ADDENDUM

Project: Craft State Office Building 1 HVAC
– 200 South Silber Avenue, North
Platte, NE, 69101

Project No.: 23059

Addendum No.: 1

SECOND AND THIRD
FLOOR PLAN -
MECHANICAL

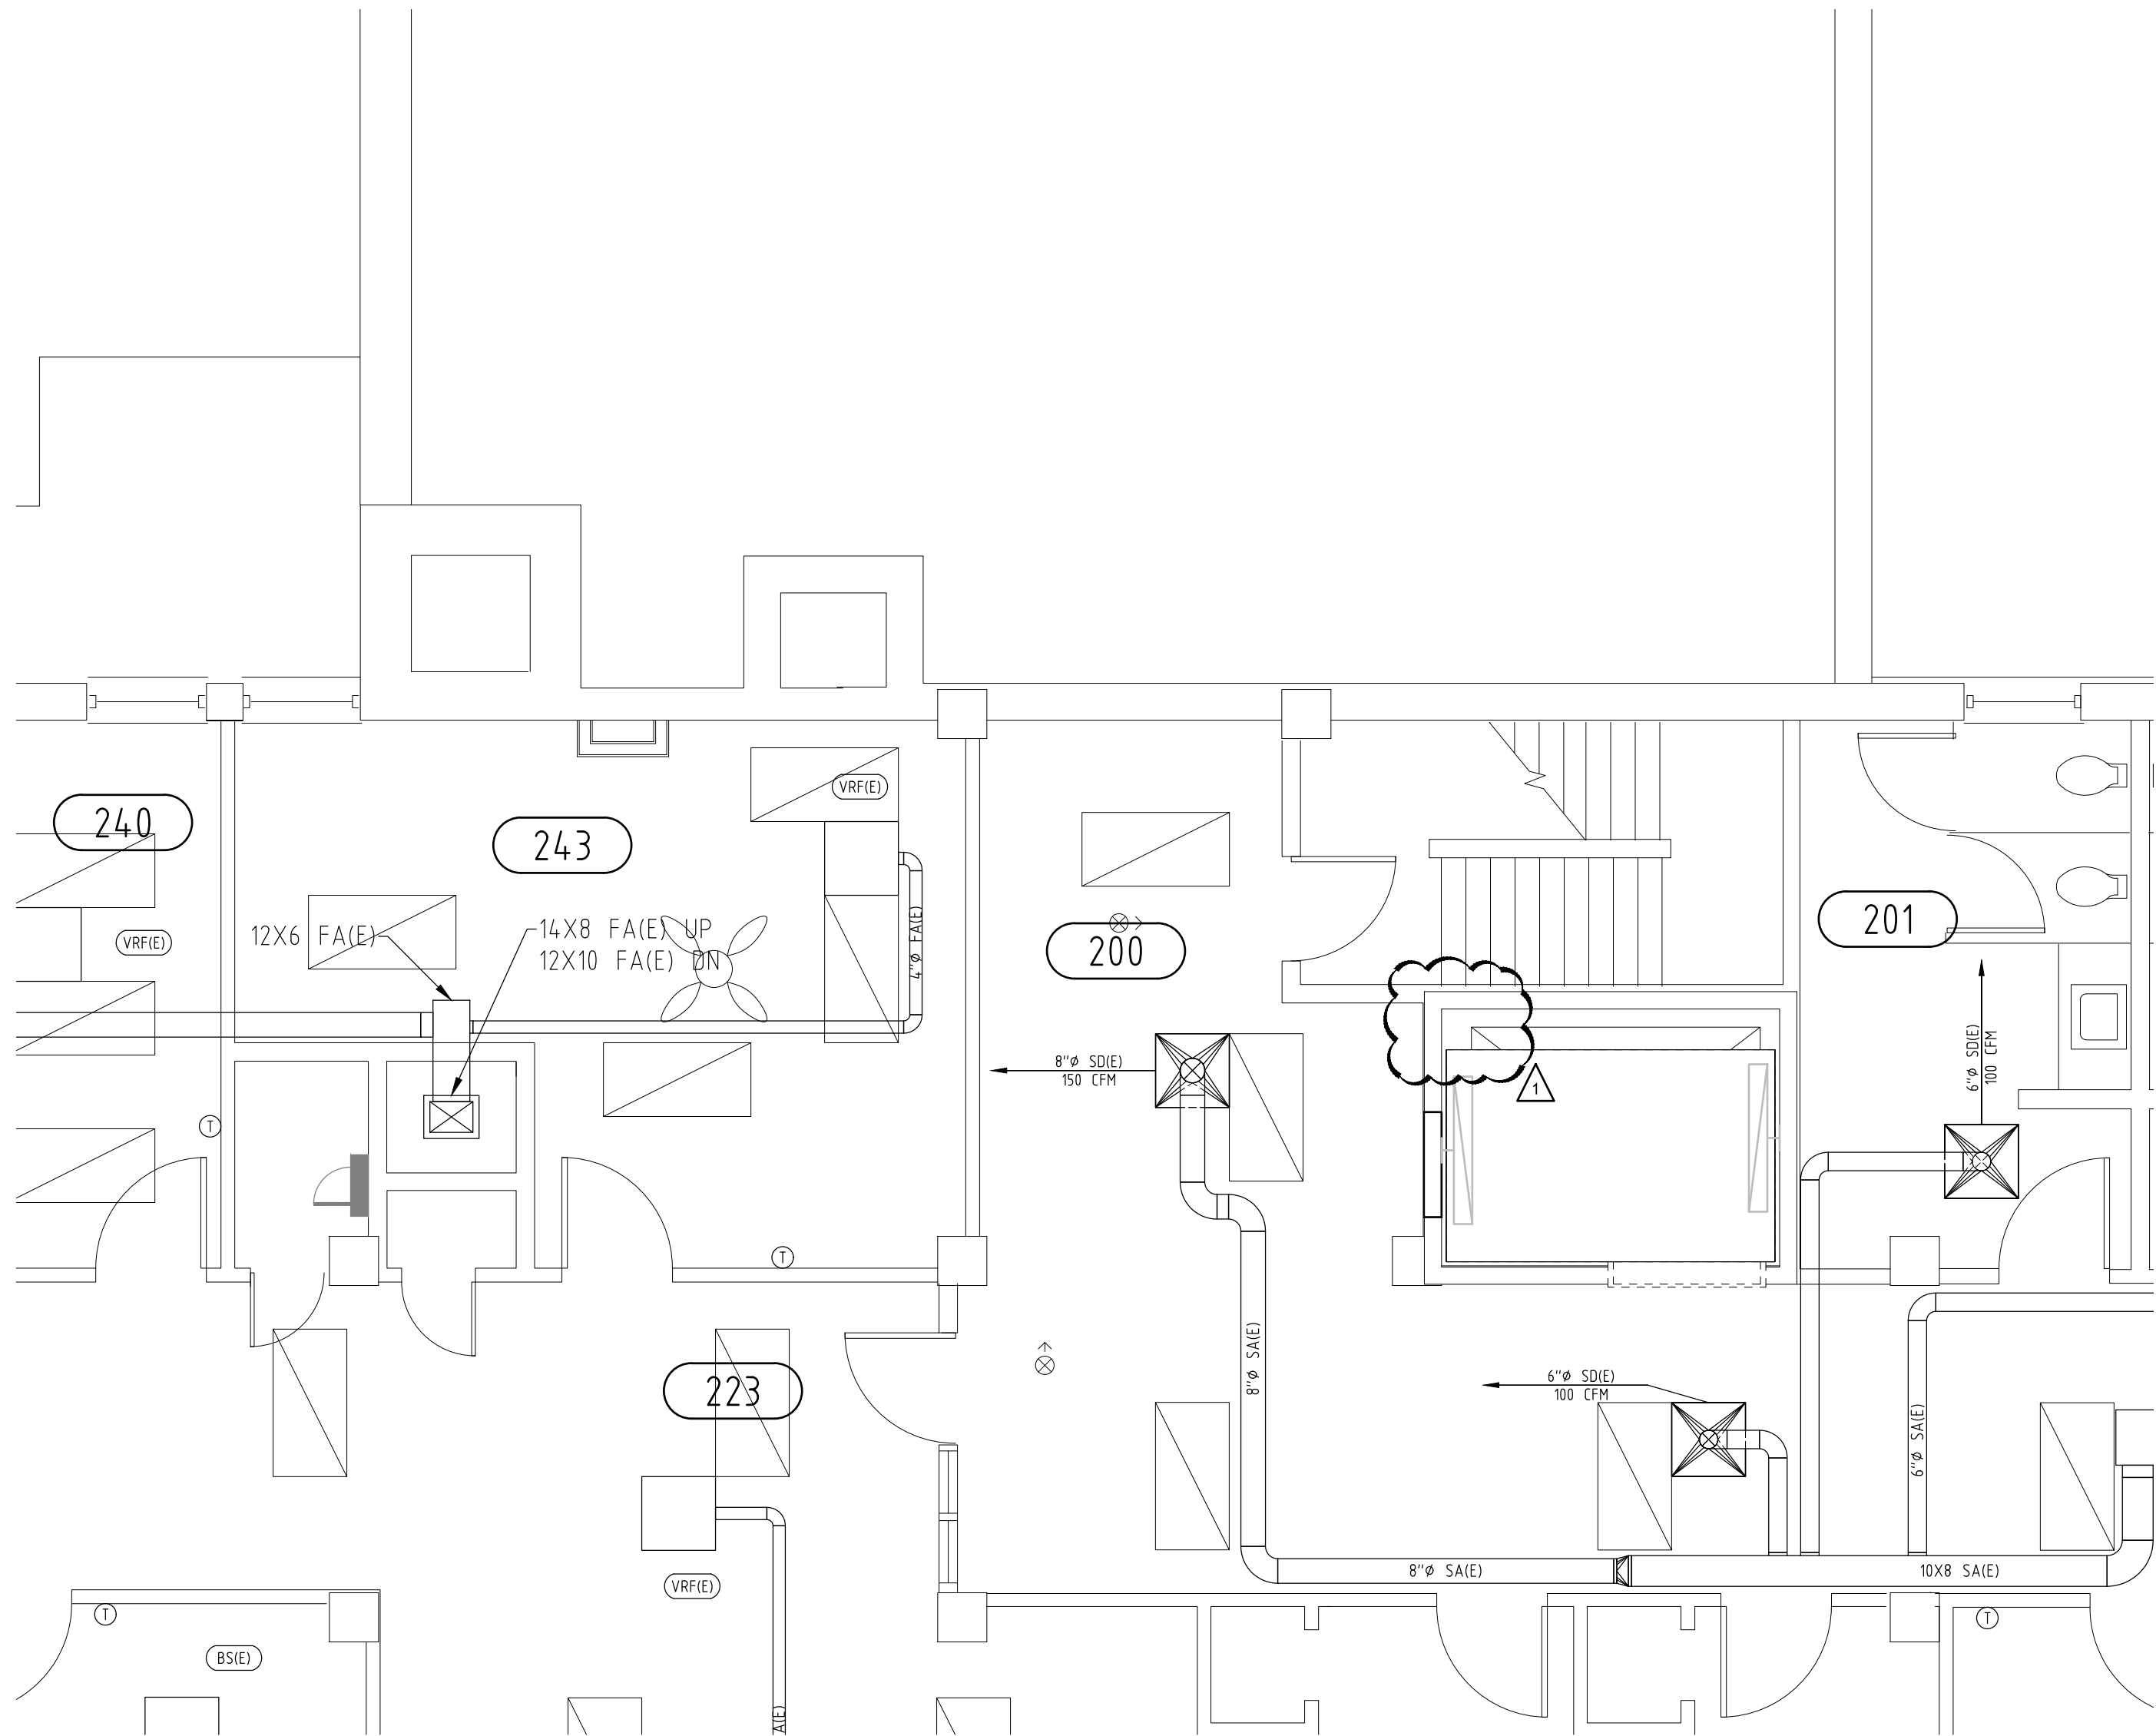
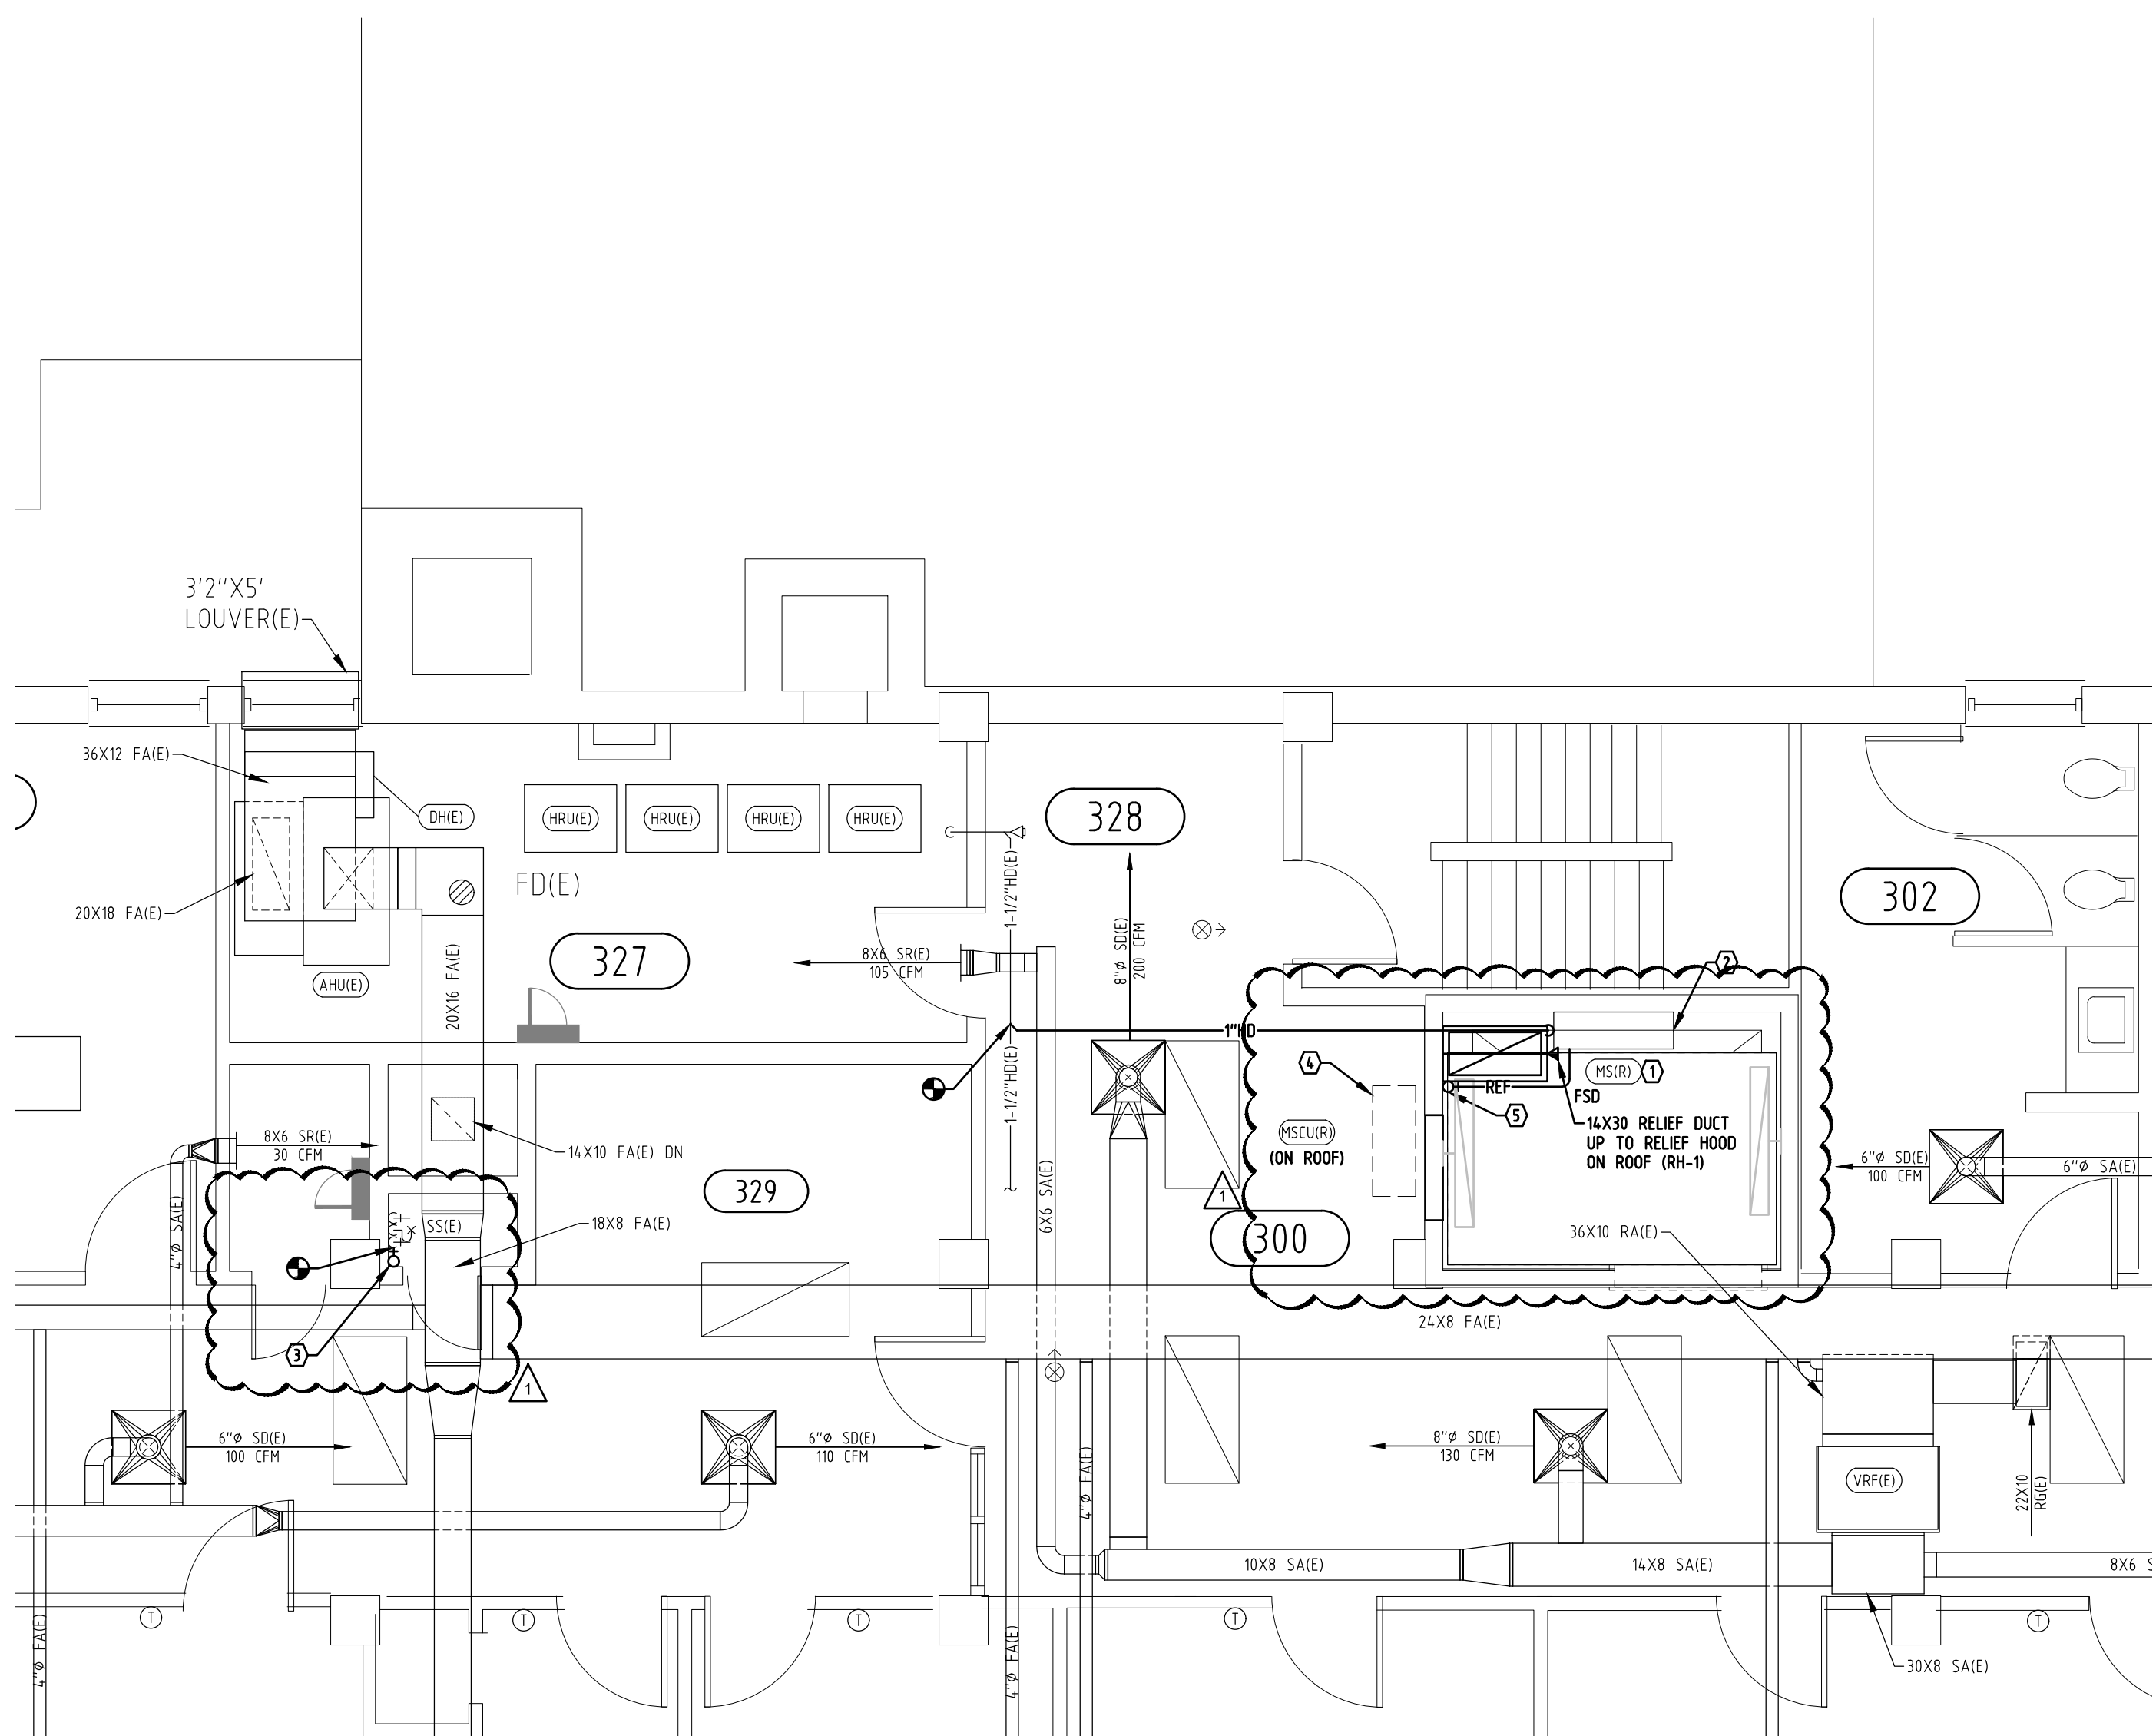
1. **T0.0 – Title Sheet**
 - a. Several notes we added to the "Overall Project Phasing Schedule."
 - b. Outlined alternative and base bid proposed by structural.
 - c. Added sheet to Structural Sheet list.
2. **M1.1 - GROUND & FIRST FLOOR PLAN - MECHANICAL**
 - a. Keynote 3 has been revised to specify relocating the (E)MSCU.
 - b. Keynote 4 has been revised to specify the removal of the existing refrigerant and humidity drain piping.
3. **M1.2 – Second and Third Floor Plan – Mechanical**
 - a. Keynote 3 has been revised to specify the addition of the Roof Hydrant.
 - b. keynote 4 has been revised to specify new location of (E)MSCU.
 - c. Keynote 5 has been revised to specify refrigerant piping from new location of (E)MS to new location of (E)MSCU.
4. **M2.1 – Details & Schedules - Mechanical**
 - a. Plumbing fixture schedule and RH-1 have been added to this sheet.

- SHEET NOTES** KEY NOTE SYMBOL = (K)
- KEY NOTES**
1. EXTEND HUMIDITY DRAIN FROM MINI-SPLIT IN ELEVATOR SHAFT TO EXISTING FLOOR DRAIN. VERIFY EXACT LOCATION PRIOR TO INSTALLATION.
 2. NEW LOCATION OF RELOCATED MINI-SPLIT.
 3. CONNECT 3/4" DOMESTIC COLD WATER TO EXISTING COLD WATER LINE UNDER EXISTING SINK IN JANITORS CLOSET. EXTEND NEW 3/4" COLD WATER LINE UP THROUGH ROOF TO ROOF HYDRANT. PROVIDE LOW POINT VALVED DRAIN AND ISOLATION VALVE IN JANITORS ROOM ABOVE SINK. PROVIDE 3/4" THREADED HOSE CONNECTION ON DRAIN. EXTEND PIPING UP THROUGH ATTIC AND OUT ROOF. PATCH AND FLASH ROOF AS REQUIRED.
 4. NEW LOCATION OF RELOCATED MINI-SPLIT CONDENSING UNIT IS ON THE ROOF. SUPPORT UNIT ON POWDER COATED BLACK METAL WALL BRACKETS SECURED TO EXTERIOR WALL.
 5. EXTEND REFRIGERANT PIPING UP THROUGH SPACE ABOVE ELEVATOR AND OUT OF SOUTH WALL TO MINI-SPLIT CONDENSING UNIT.
